Notice

Category : **DVD Player**

Model : **DVD-9201, 9501, 9501KR, 9501PR**

Issue Number : **1**

(Caution of pick up on DVD base mechanism.)

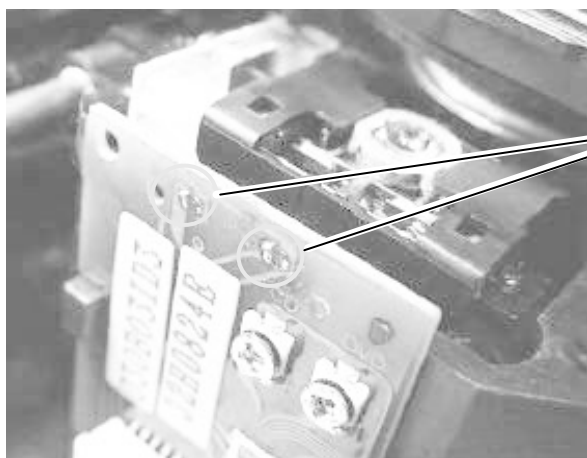
Before disconnecting FFC cable, make it "SHORT" as shown left.
After connecting FFC cable, make it "OPEN" as shown left.
